Product / Process Change Notification (PCN)

PCN #: PCN_UtRJ45LAN_20230811
Affected Series: WE-UtRJ45LAN-Series: 7498xxx
PCN Date: May 11, 2023
Effective Date: August 11, 2023

To ensure an improved product assembly, Würth Elektronik will implement a new spot welding design technology. Along with this, further general improvements are done in design and process, like wire to shield insulation. Additional Würth Elektronik will change to new data sheet format & correct datasheet mismatches. All products with date code 2023-08-11 or later, will be affected by this change. There will be no change in fit and function of the product.

Above: Overview of the physical change

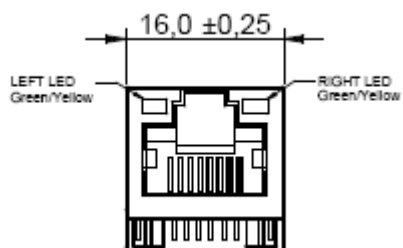
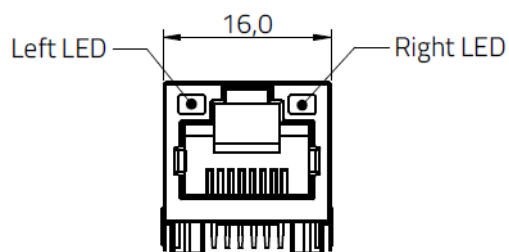
Above: Improved positioning of the PCB

Above: Improve internal insulation with change from tape to plastic cover

Above: Change in PCB layout to enhance product standardization

74980104400:

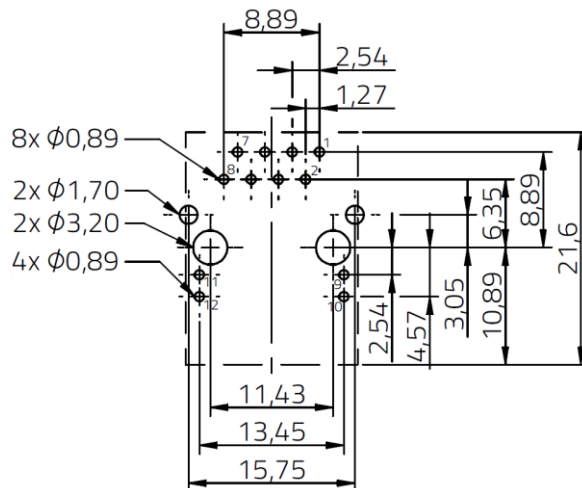
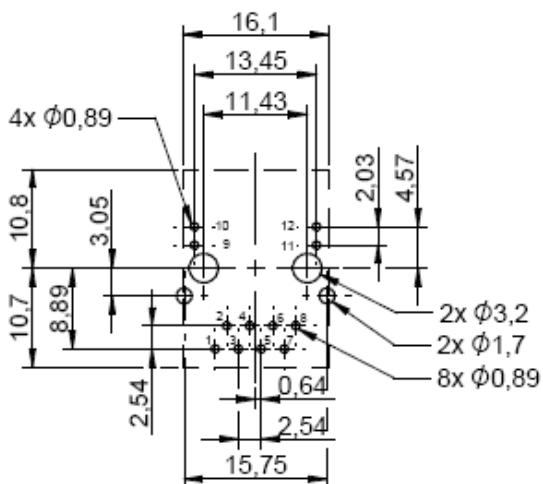
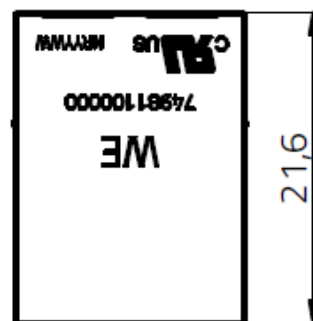
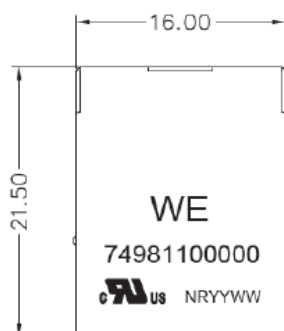
Before correction

After correction

74981100000:

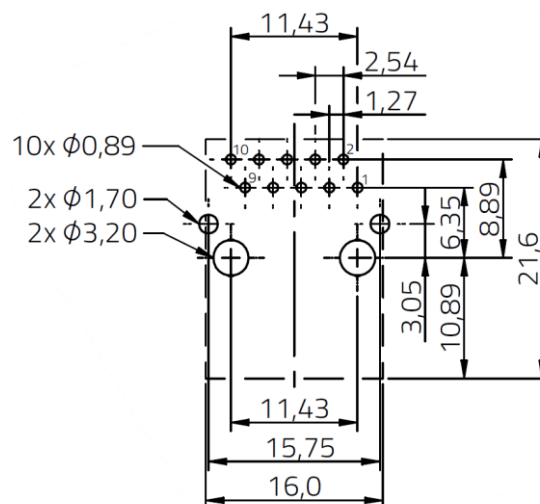
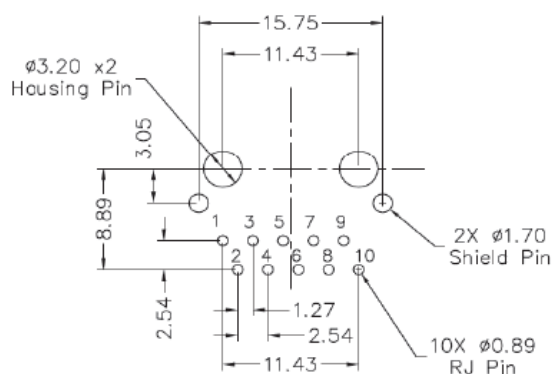
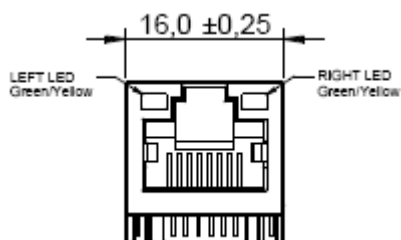
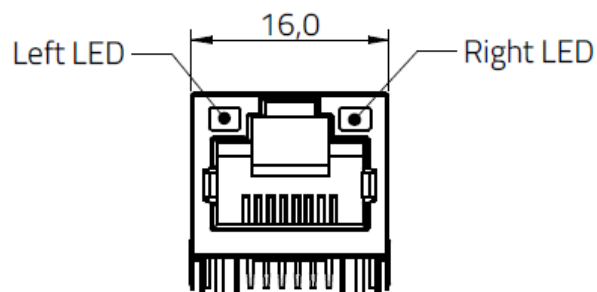
Before correction

After correction

74981104400:

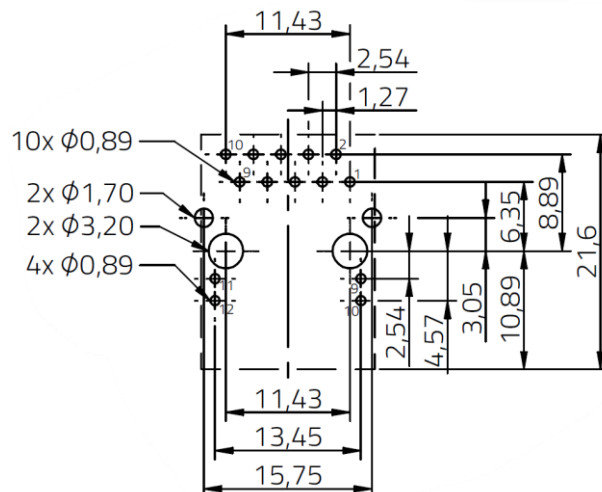
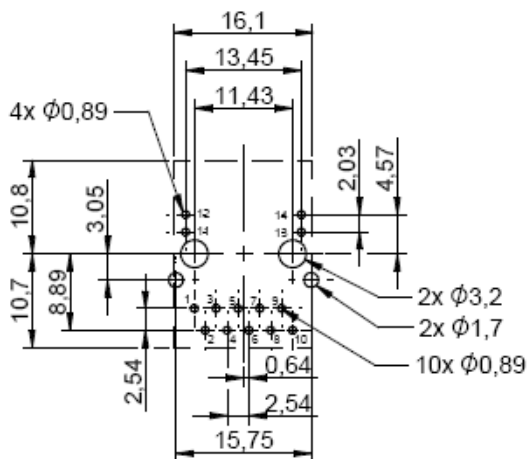
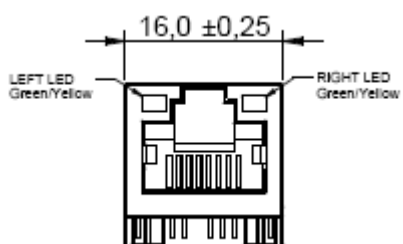
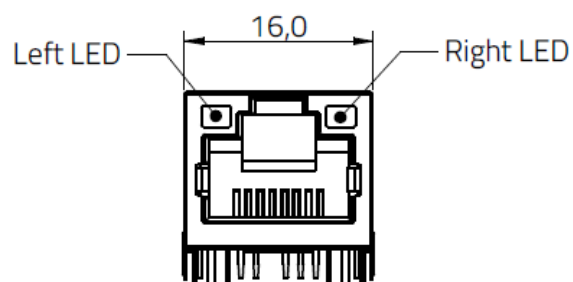
Before correction

After correction

74982104400:

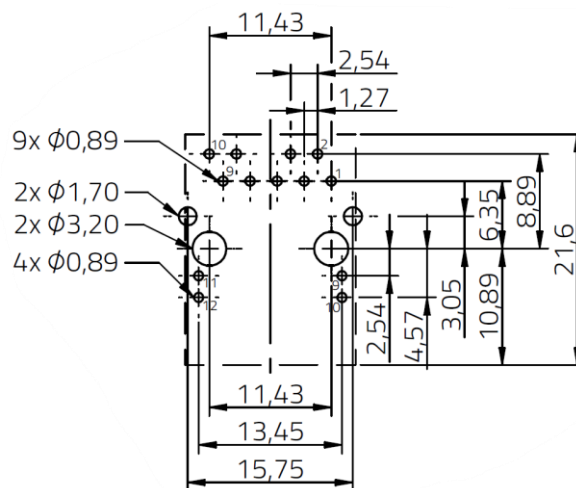
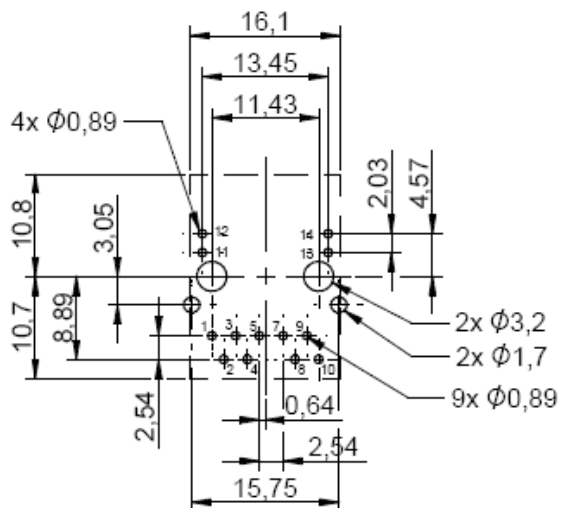
Before correction

After correction
